TECHNICAL INFORMATION

TI0519

Material change for solenoid valve

SiGusto / CVS / CIS / SiVend HG

Brass solenoid valve
402 00 954 01

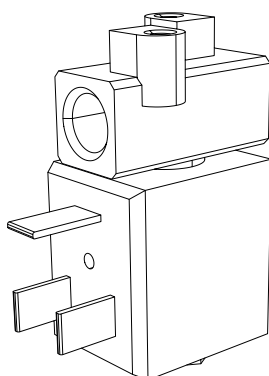
The material used for the inlet valve on hot drinks machines has been changed.

To continue to guarantee availability of this spare part the previous solenoid valve made from brass, part no. 402 00 954 01, has been replaced by a new plastic solenoid valve, part no. 414 00 948 00.

Machines supplied before Week 7 /2019 will require a special kit as the plastic solenoid valve is smaller.

On account of the change of material, screws for plastics are required when fitting the solenoid valve. These screws are included in the kit. Screws for installing the solenoid valve must not be tightened with more than 1,2 Nm. The hose connections must not be tightened with more than 2,0 Nm.
